STAFF REPORT

MEETING DATE: August 7, 2014

DSA-14-00044: Major Site Plan/Final Development Plan for a proposed 6,972 square foot O'Reilly Auto Parts store located at 1426 E. Florence Boulevard.

Applicant's Conceptual Site Plans:

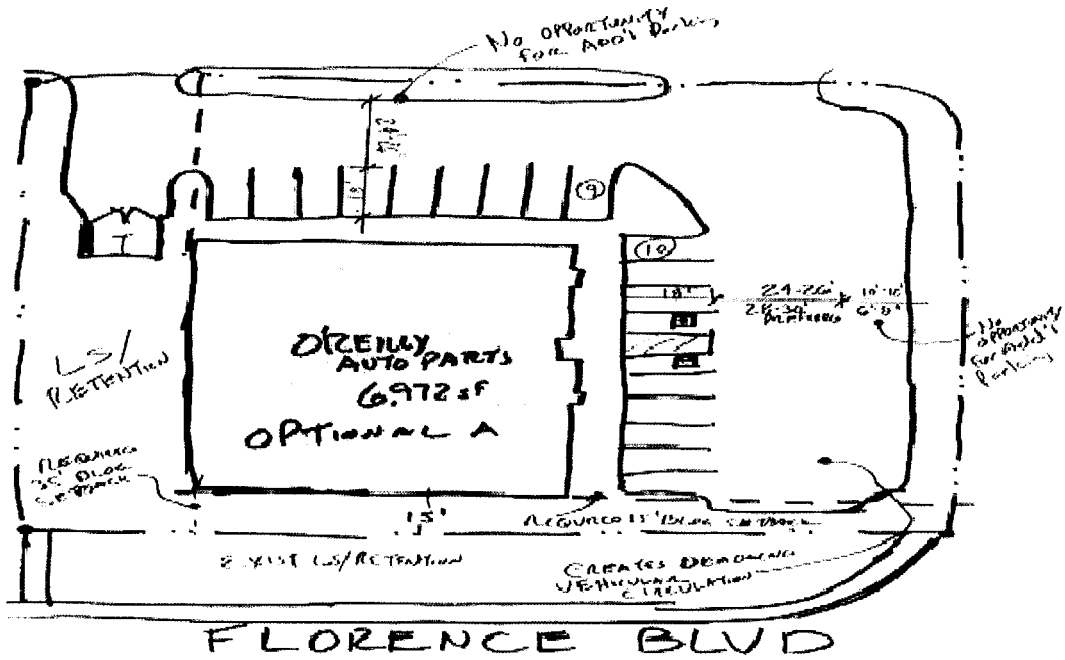
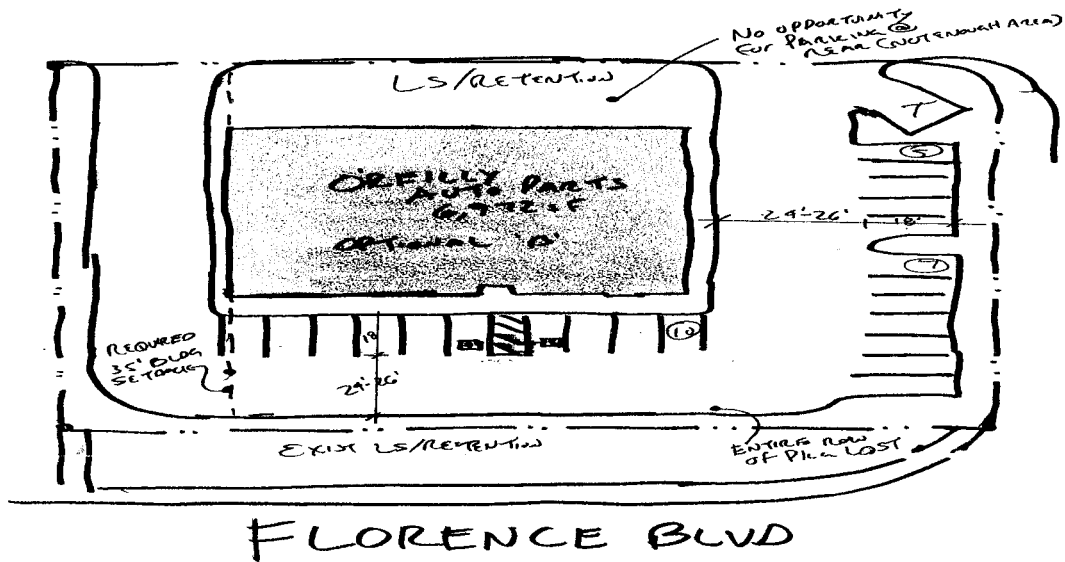
Staff discussed compliance with the Community Center land use design objectives with the applicant and how it can be achieved with this site with a fairly simple modification of their typical pro-typical site plan. However, the applicant has informed Staff that this type site design does not work with well with the nature of an O'Reilly store. Staff has provided the applicant site design modification suggestions that would allow them to fairly easily meet the design intent of the Community Center land use category but the applicant did not feel a building orientation that brought the building closer to the street and the parking to side would meet their needs.

Staff's Conceptual Site Plan:

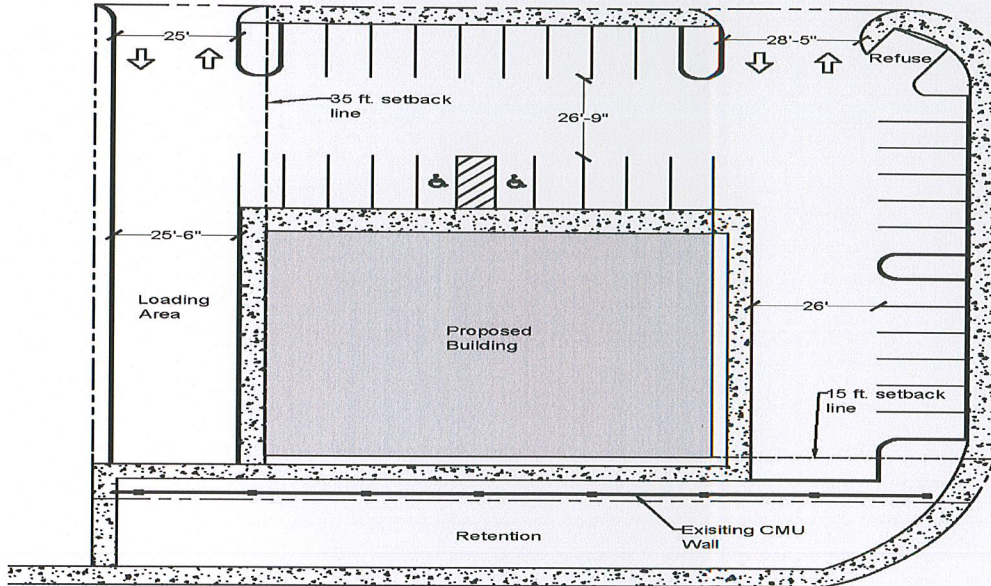
Staff's site plan exceeds the 28 parking spaces required and meets the minimum requirements for drive aisle width (25'). As shown on the conceptual site plan the building was placed closer to the street and provides direct pedestrian access, which meets the spatial form and design of the Community Center land use criteria.

Exhibit A – Site Plan

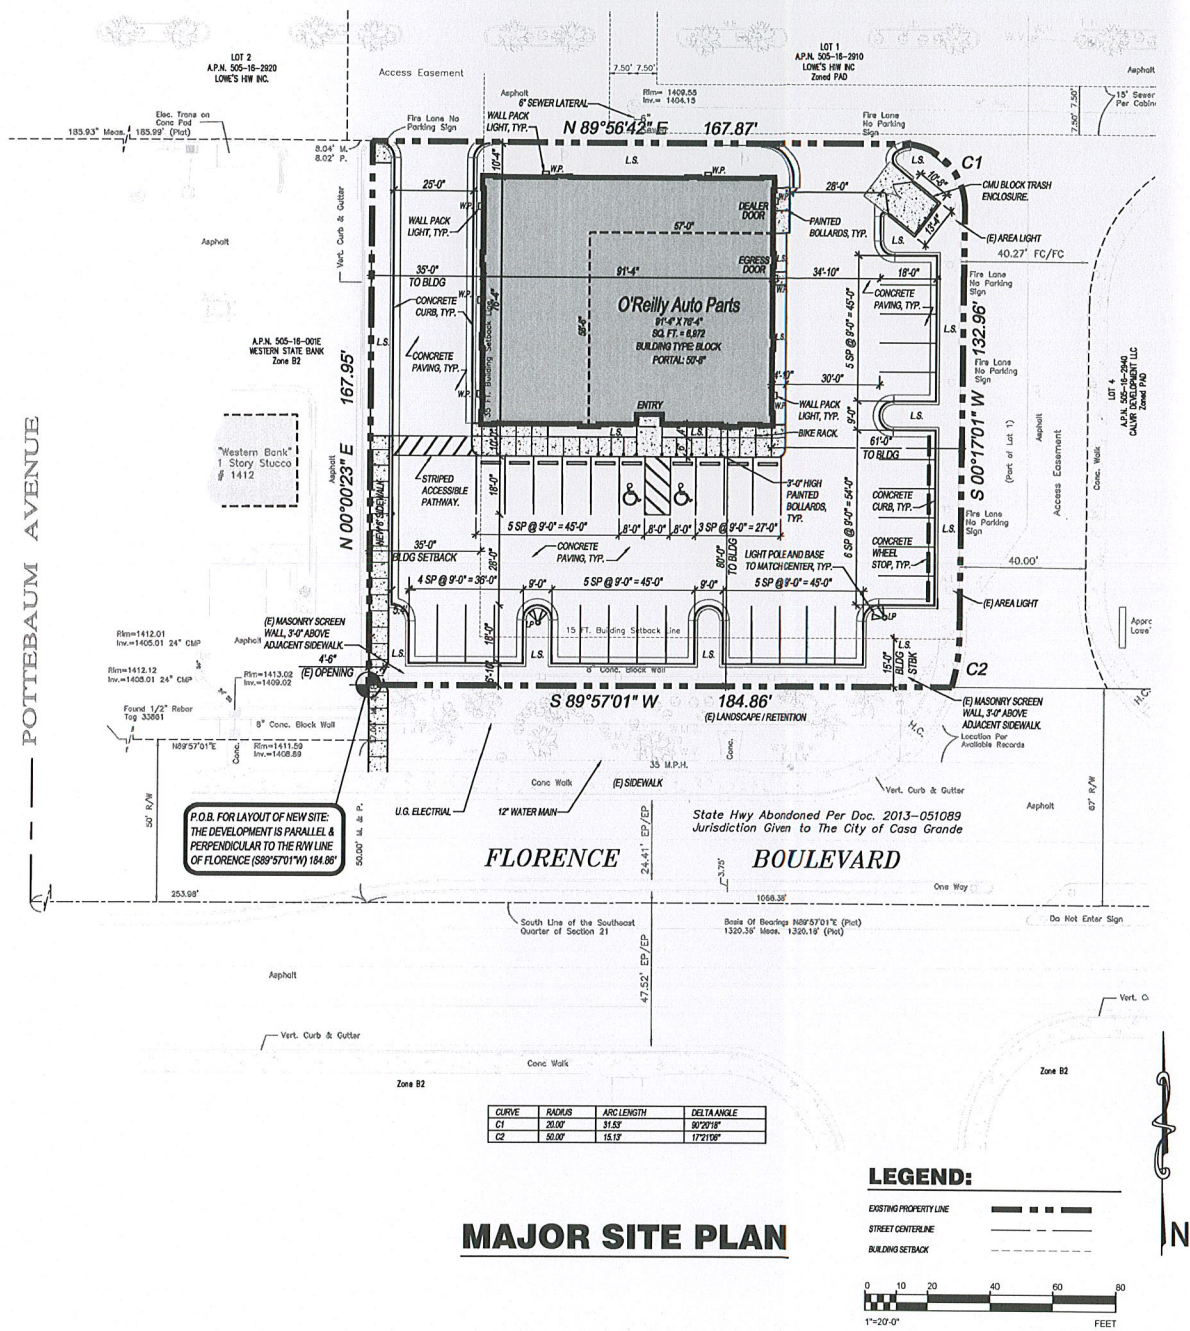
The Major Site Plan request is for an O'Reilly Auto Parts store. The site (.72 acres) will consist of a one story, 6,972 square foot building located on the vacant pad site at the Lowe's shopping center (see Exhibit A).

Parking requirements for the site are based on the code requirement of one space per 250 square feet of floor area. Based on this calculation the building is 6,972 square feet and the required number of parking spaces is 28 spaces. The applicant is providing 35 parking spaces which exceed the minimum requirements.

Truck deliveries to the site would enter the existing Lowe's drive aisle off of Florence Boulevard. Larger vehicles are anticipated to maneuver with the Lowe's parking area and back into the subject site using the east access for loading and unloading. It is recommended that deliveries be limited during business hours to avoid conflicts with customers entering and exiting the site. Smaller delivery vehicles are not anticipated to require backing maneuvers and can occur during all hours.

The site will have pedestrian connectivity with the proposed sidewalk extension from Florence Boulevard extending north into the site. The proposed sidewalk is six feet wide and can be accessed through the existing gate of the perimeter fence. The site will also provide a bike rack located on the south side of the building. This design feature is about the only aspect of the project that meets the objectives of the Community Center land use category.

1. The proposal is not in conformance with the design intent of the Community Center land use category of the General Plan 2020.

Exhibit B – Preliminary Landscape Plan

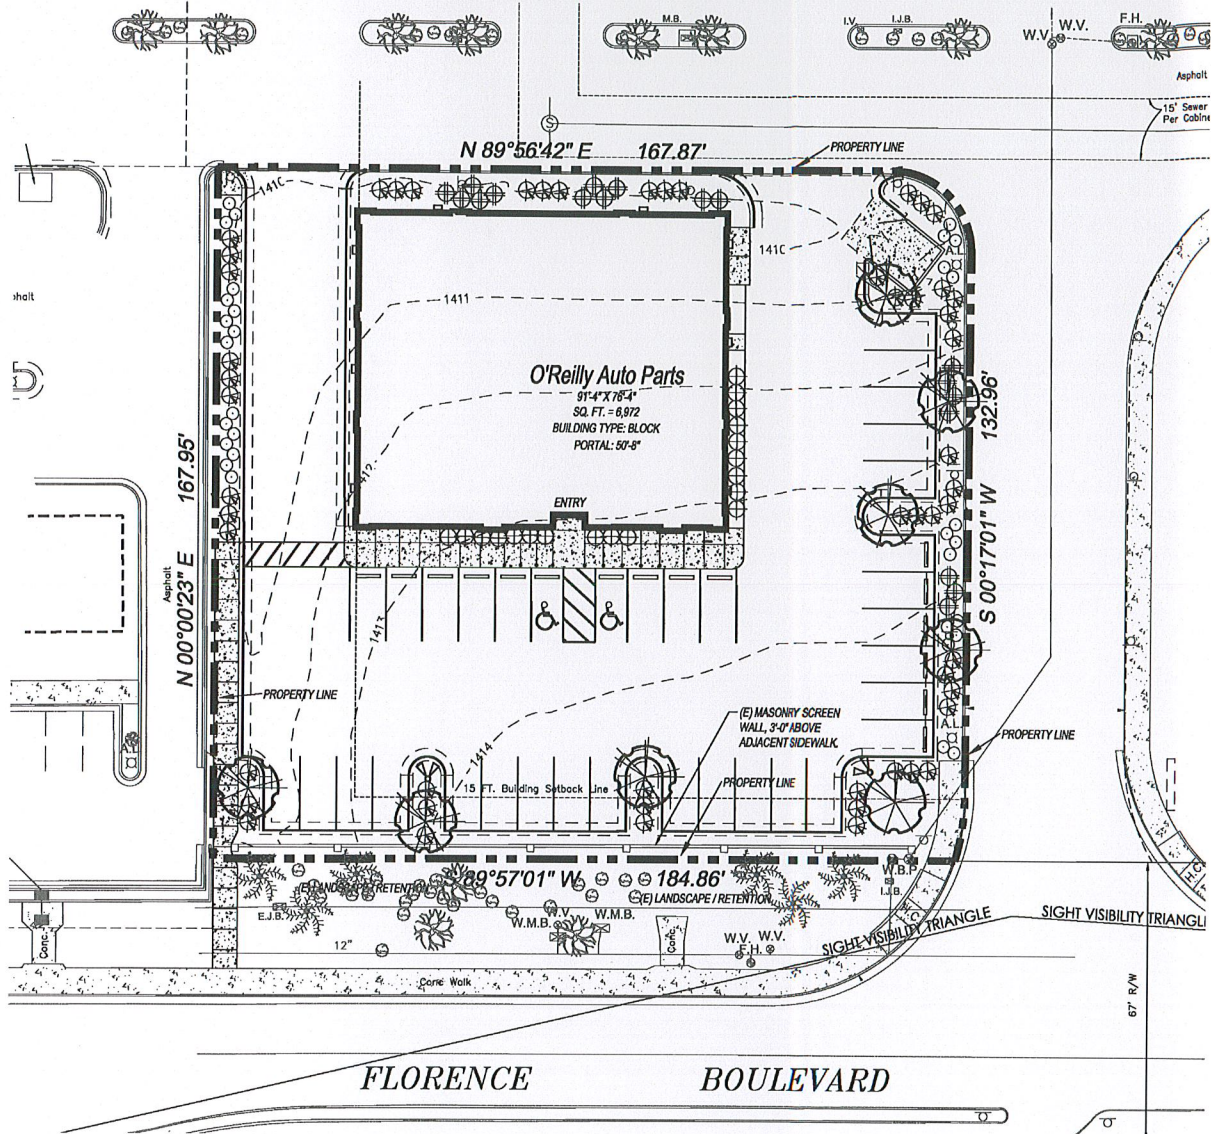
The preliminary landscaping plan for the site (See Exhibit B – Preliminary Landscape Plan) indicates that the site is generally in compliance with the landscape code. The landscaping along the perimeter of the site was established with the Lowe's Shopping Center; therefore the remaining landscaping to be installed will be on-site. The specific breakdown of the calculations will be provided with a final landscape plan at the time of building permit submittal.
